## UTPB – Valet and Driveway Reno

**UTPB - VALET AND DRIVEWAY RENOVATION**  
6410 Fannin Street/ Houston, Texas 77030

**Date:** December 16, 2019  
**Johnston Project No.:** 19-00032-00  
**Prepared by:** Paula Gaviria

1. This Addendum addresses architectural, mechanical and electrical revisions as noted below, per comments from EH&S:

MECHANICAL  
DUCTWORK PLAN -  
LEVEL 1

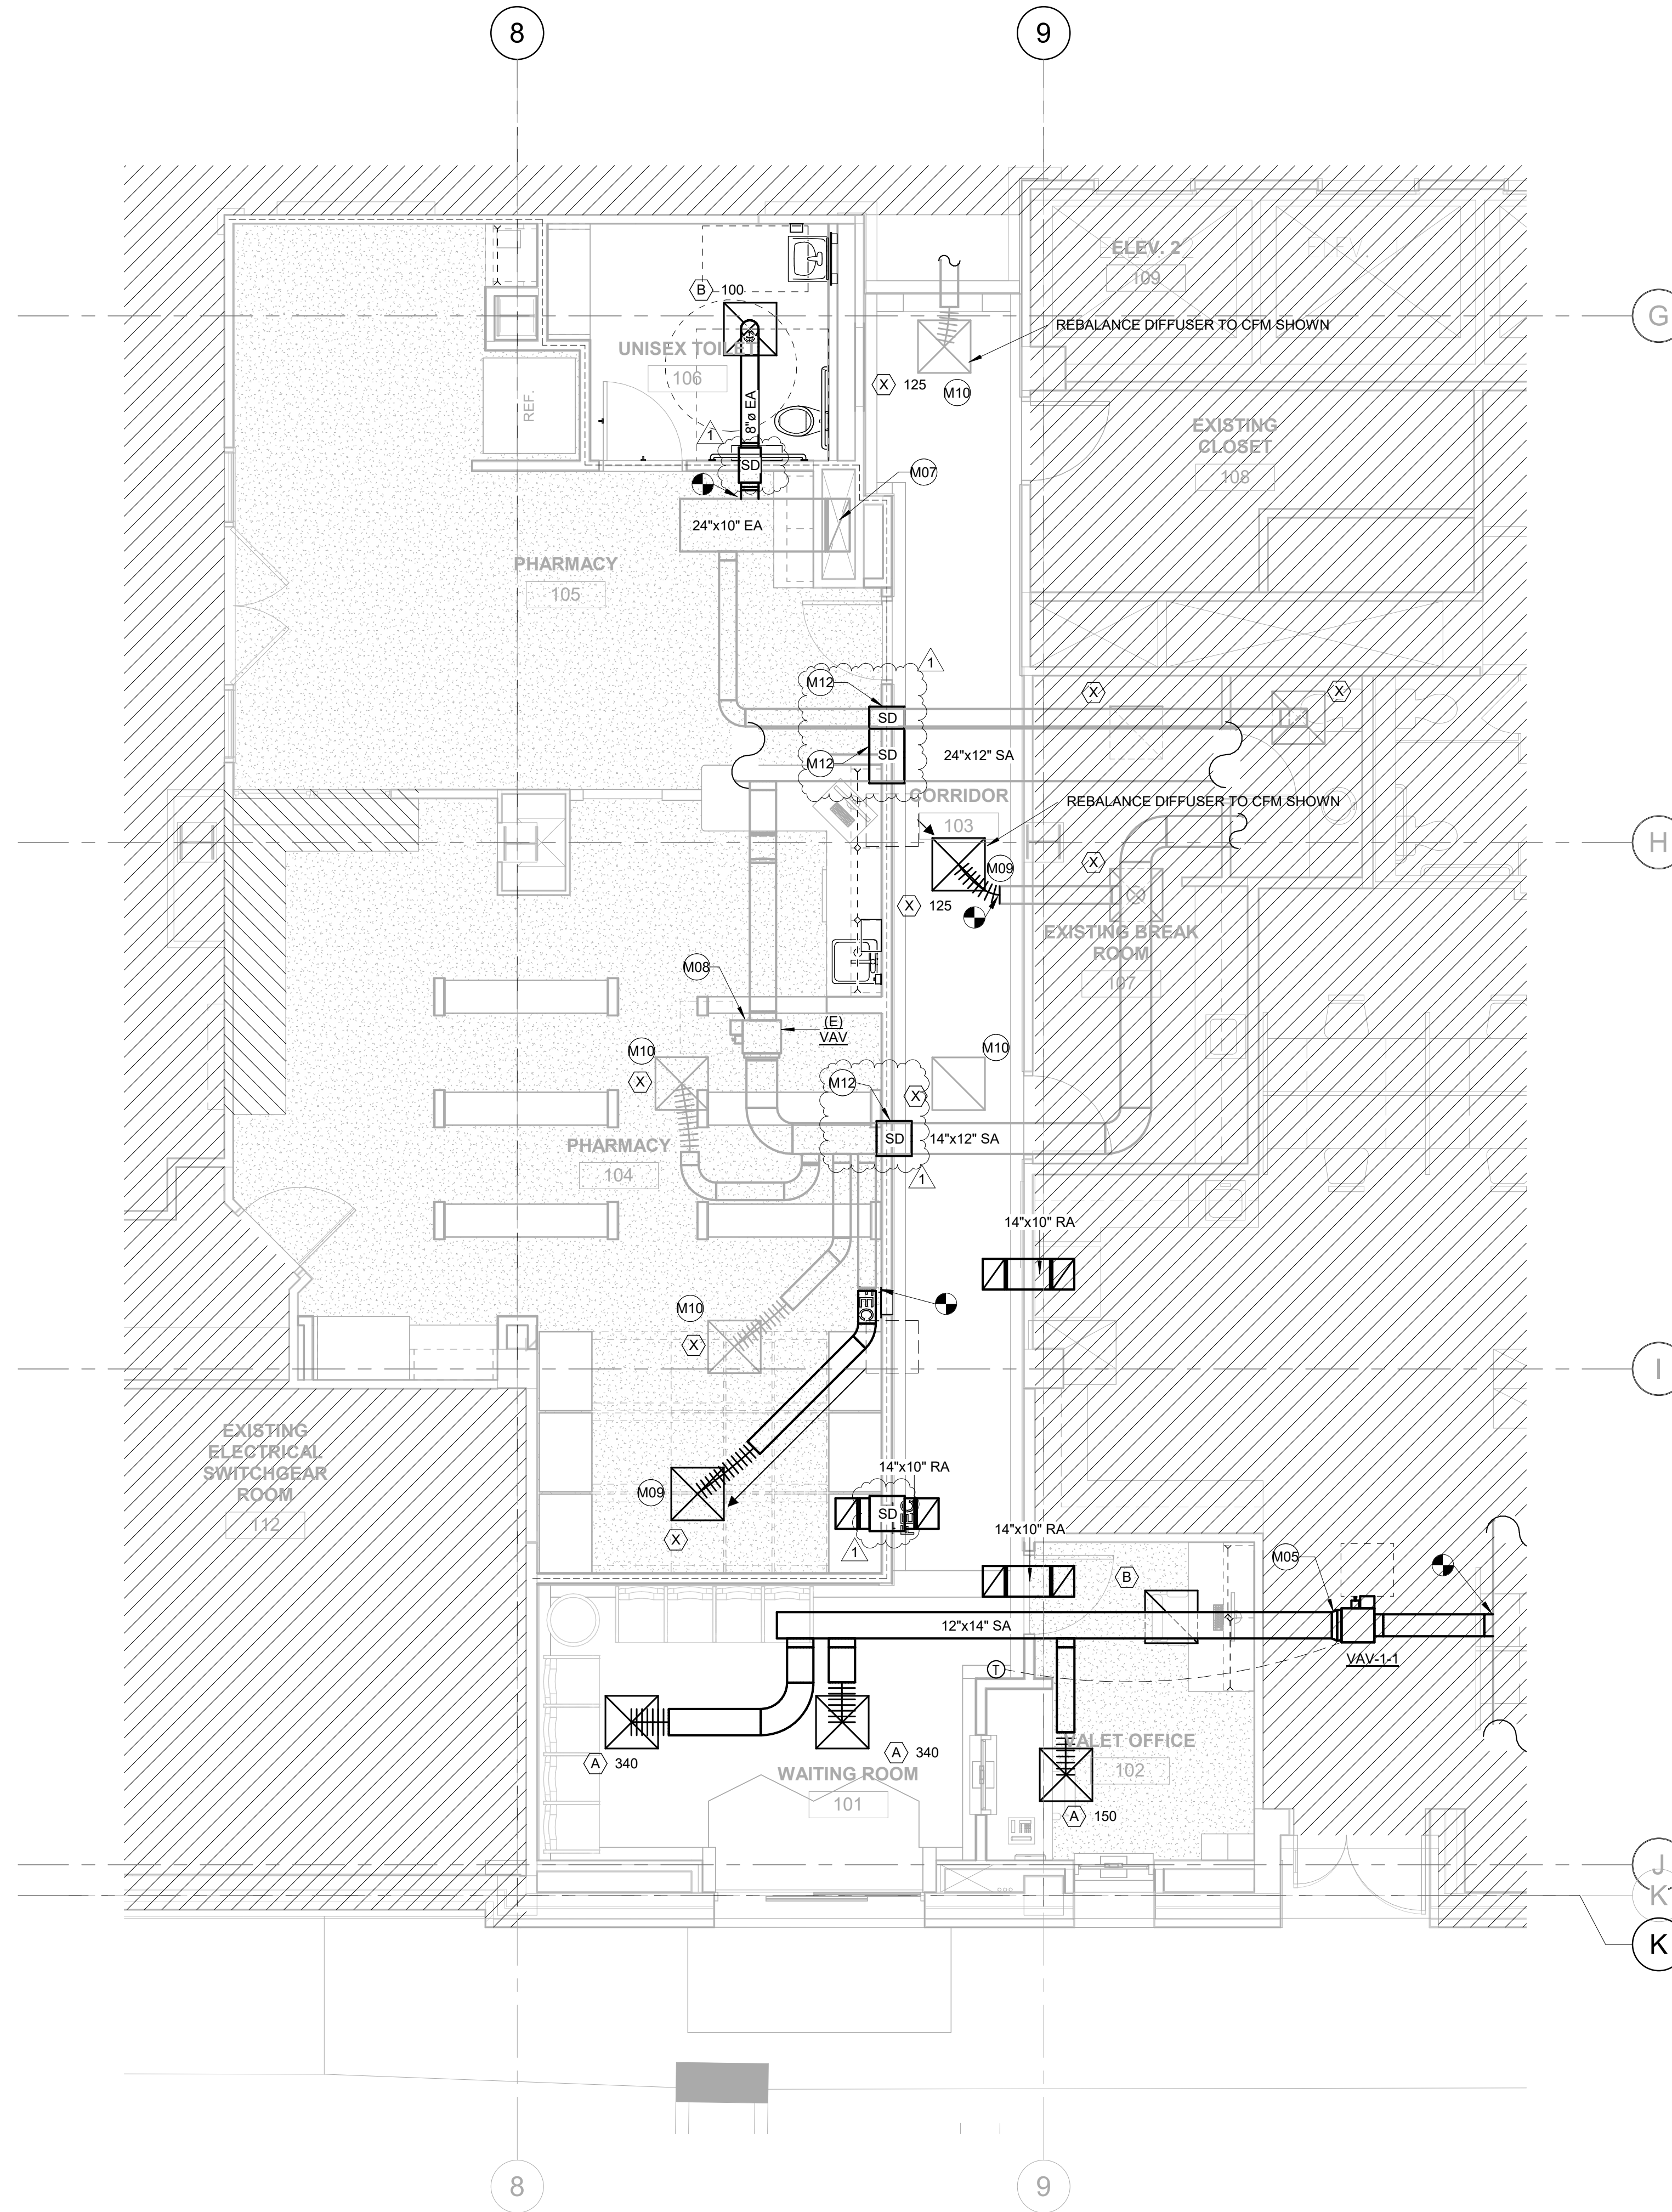
1. M0.01: MECHANICAL SCHEDULES, CONTROLS, AND DETAILS
  - Replaced detail for smoke dampers.
2. M2.01: MECHANICAL DUCTWORK PLAN – LEVEL 1
  - Revised keynote number 12 referring to smoke damper installation.

- M05 INSTALL NEW VAV. RE-BALANCE EXISTING AHU TO ACCOMMODATE NEW VAV BOX. REF: SCHEDULE.
- M07 BALANCE EXHAUST RISER.
- M08 TAKE PRE-READINGS AND REBALANCE-TERMINAL UNIT. AFTER SETTING AIRFLOW AT DIFFUSER IN CORRIDOR. RELOCATE THERMOSTAT IF NECESSARY
- M09 RELOCATE EXISTING DIFFUSER TO NEW LOCATION, EXTEND DUCT AS NECESSARY. REF: M2.01.
- M12 INSTALL SMOKE DAMPER INTO EXISTING DUCTWORK.

SHEET TITLE:  
**ELECTRICAL SITE  
PLAN**

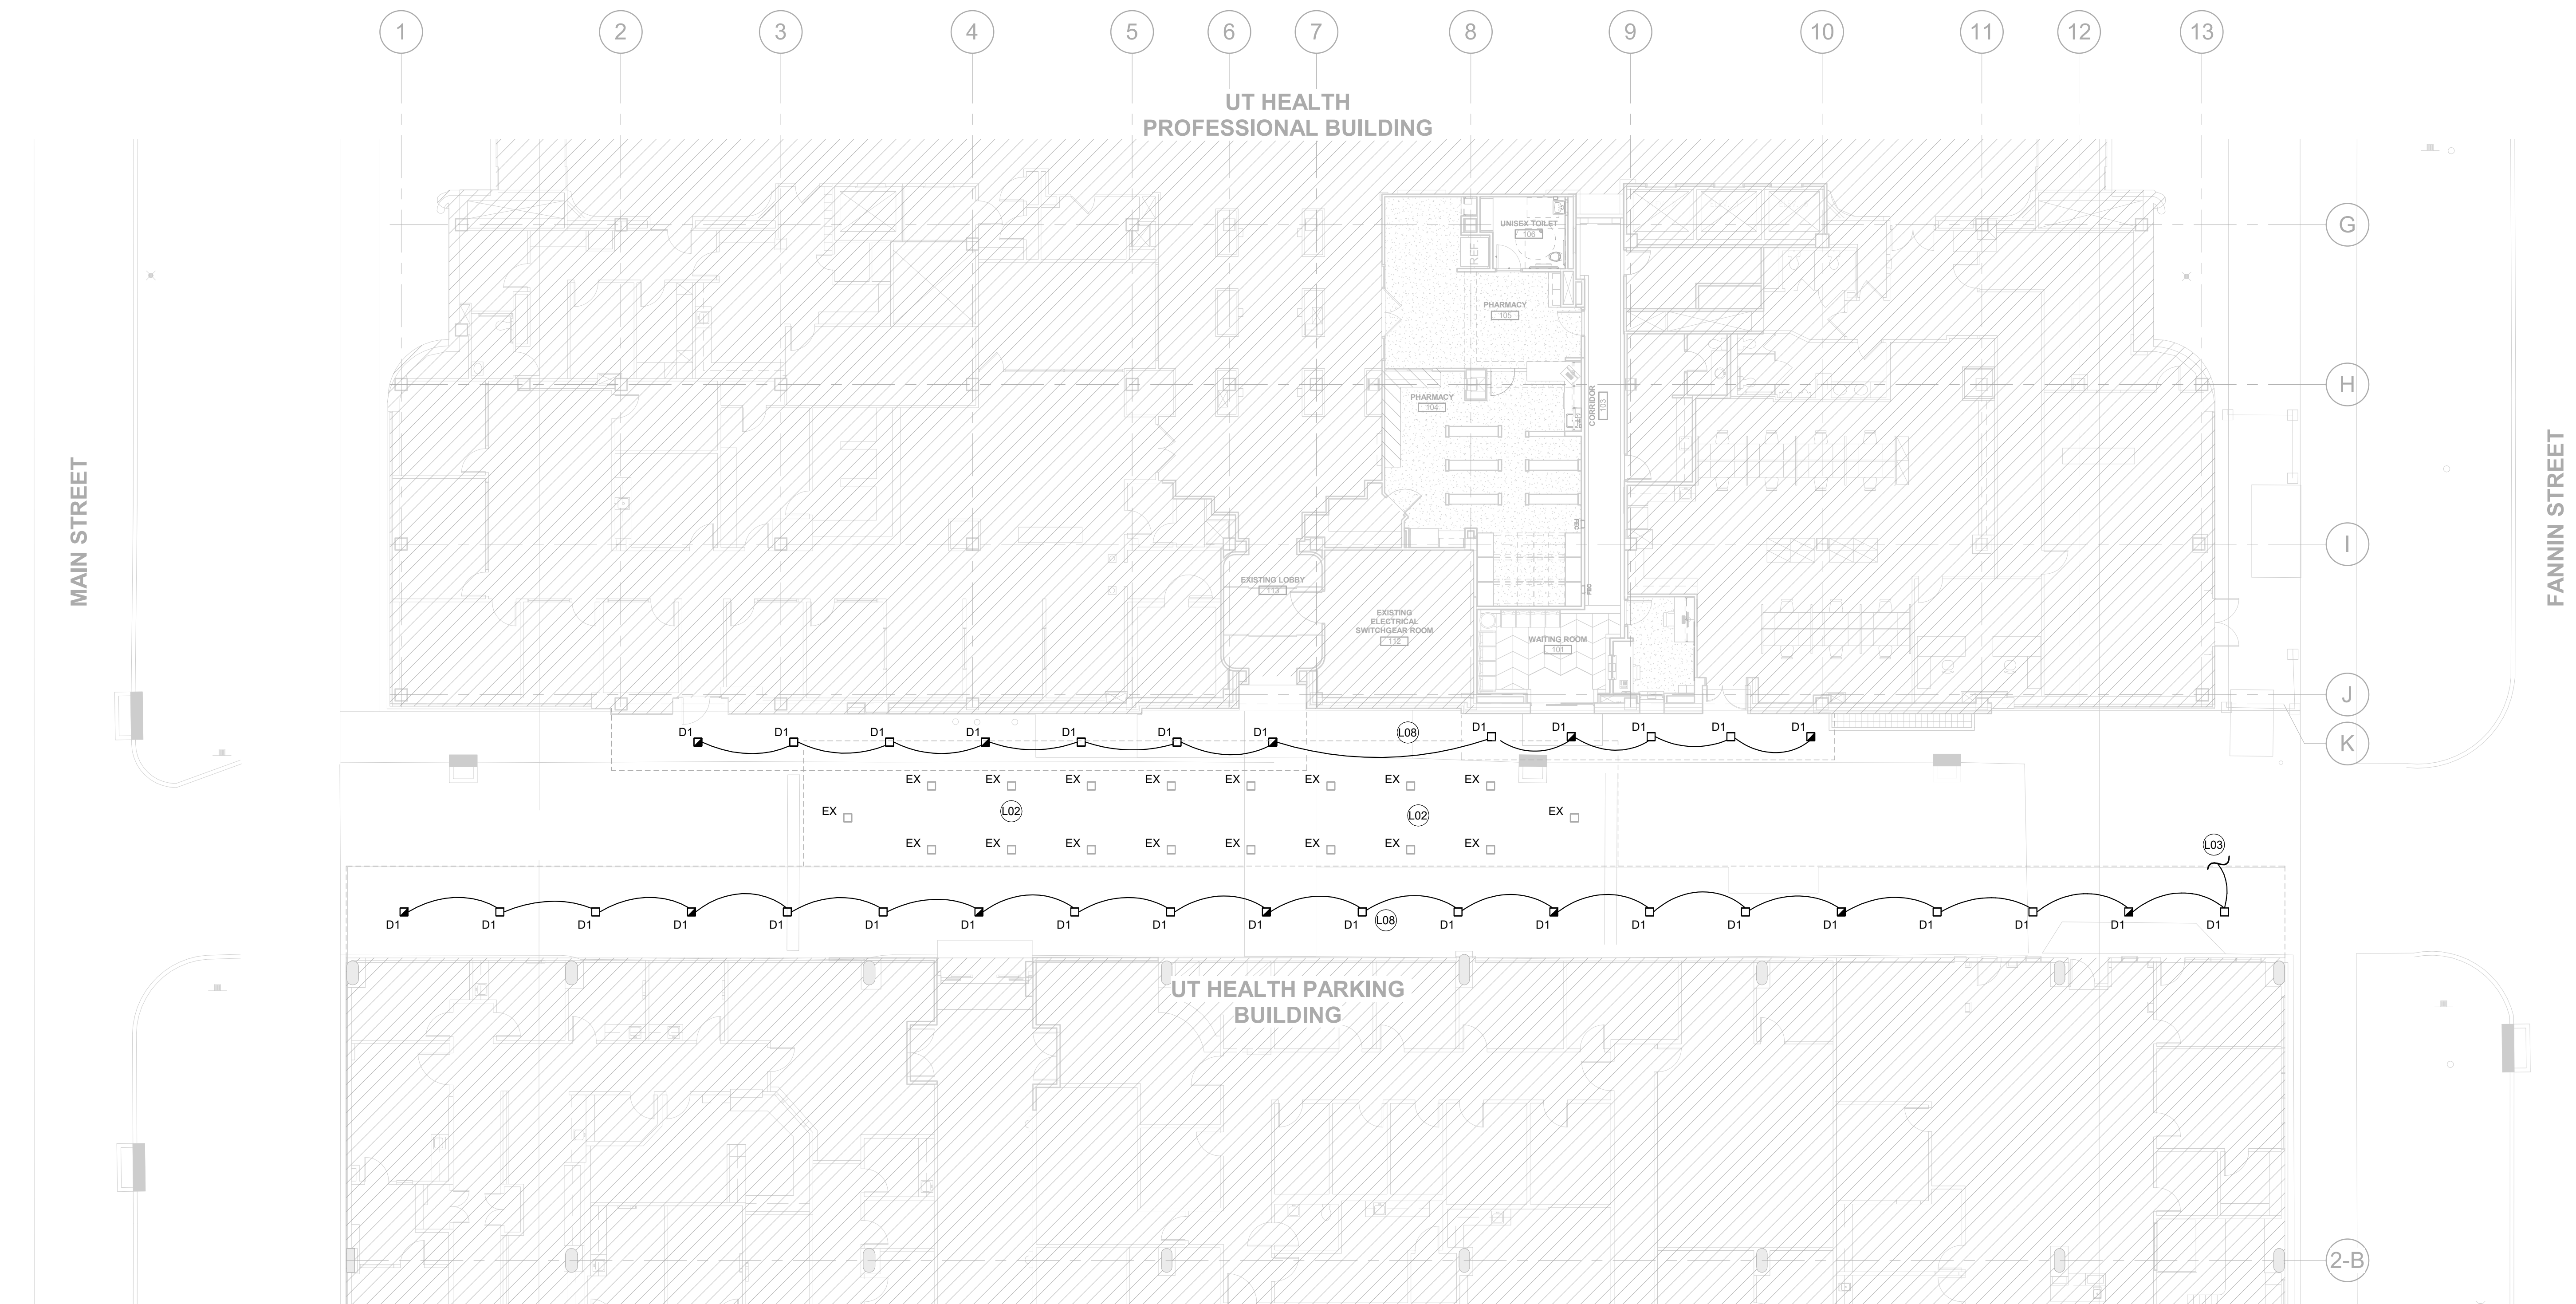
1. E1.01: ELECTRICAL SITE PLAN
  - Revised keynote L03 referring to existing lights
2. E2.01: ELECTRICAL LIGHTING PLAN – LEVEL 1
  - Revised emergency lighting in Waiting Room and Valet Office.
  - Added exit sign to Corridor.
3. E3.01: ELECTRICAL POWER PLAN – LEVEL 1
  - Added outlets to Corridor and Valet Office.
4. E5.01: ELECTRICAL FIRE ALARM PLAN – LEVEL 1
  - Added fire alarm pull string to Waiting Room.
  - Added and relocated fire strobes.
  - Added a smoke detector to Pharmacy.

- L02 LIGHT FIXTURES ARE EXISTING TO REMAIN UNLESS NOTED OTHERWISE. (TYPICAL)
- L03 VERIFY THAT A PORTION OF THE CANOPY LIGHTS ARE SERVED FROM AN EMERGENCY CIRCUIT. IF NONE ARE SERVED FROM AN EMERGENCY CIRCUIT(S), PROVIDE NEW EMERGENCY CIRCUIT(S) AS REQUIRED TO SERVE CANOPY LIGHTS, AND SERVE INDICATED FIXTURES FROM EMERGENCY CIRCUIT(S). NEW LIGHT FIXTURES ARE TO BE REPLACED IN LOCATION CURRENTLY OCCUPIED BY EXISTING FIXTURES.
- L08 REPAIR, PATCH AND PAINT CANOPY TO RESTORE TO ORIGINAL CONDITIONS.
